Compliance with EU Battery Regulations

MELSEC series, MELIPC series, and GOT2000 series

This technical bulletin informs you of changes about the following batteries and products with built-in batteries to comply with the regulations.

FA-A-0436-C

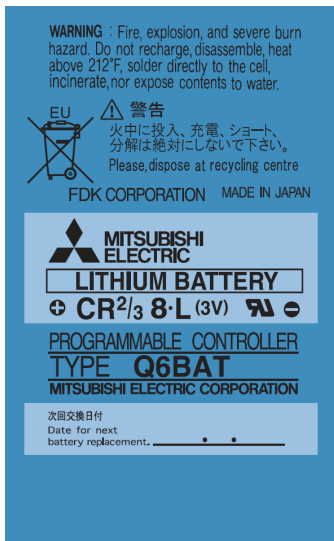
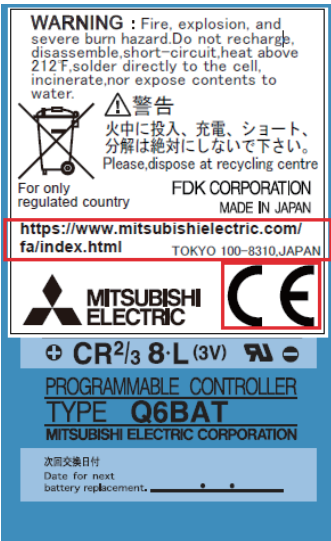
To comply with the EU Battery Regulations, the following indications will be added on the battery label or product packaging depending on the situation.

- CE mark
- Address of our head office
- URL of our website

■ Q6BAT

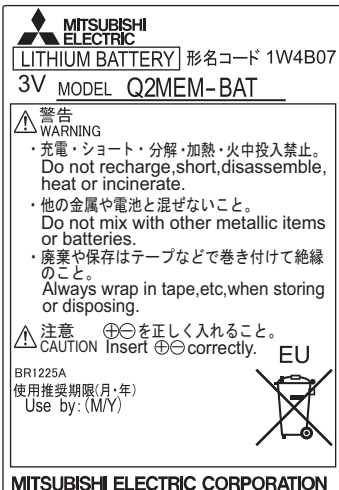
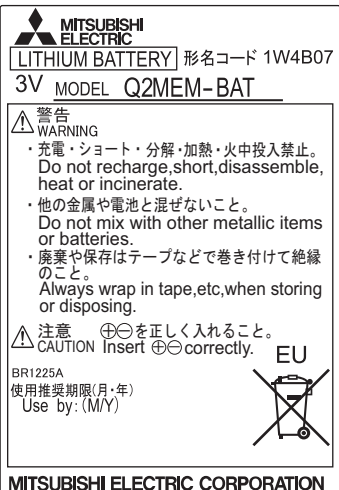
A sticker will be attached, or the label will be changed.

■ Q2MEM-BAT

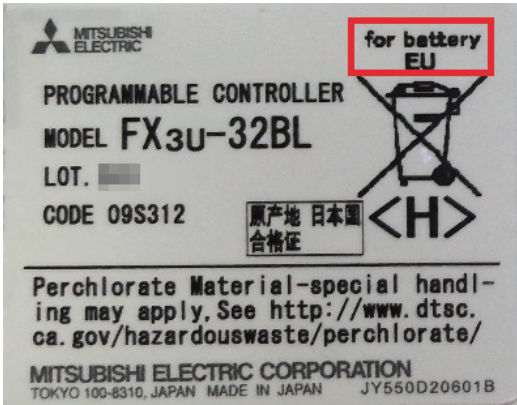
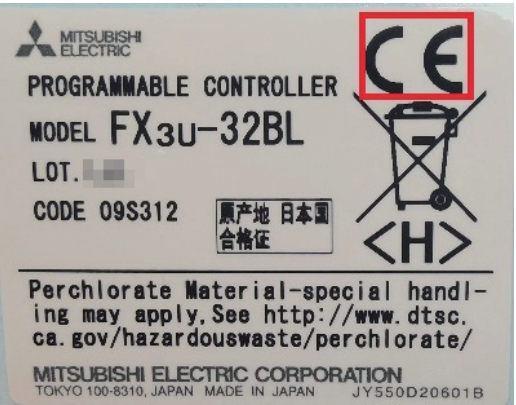
The CE mark, our head office address, and our website URL will be added on the rear of the packaging.
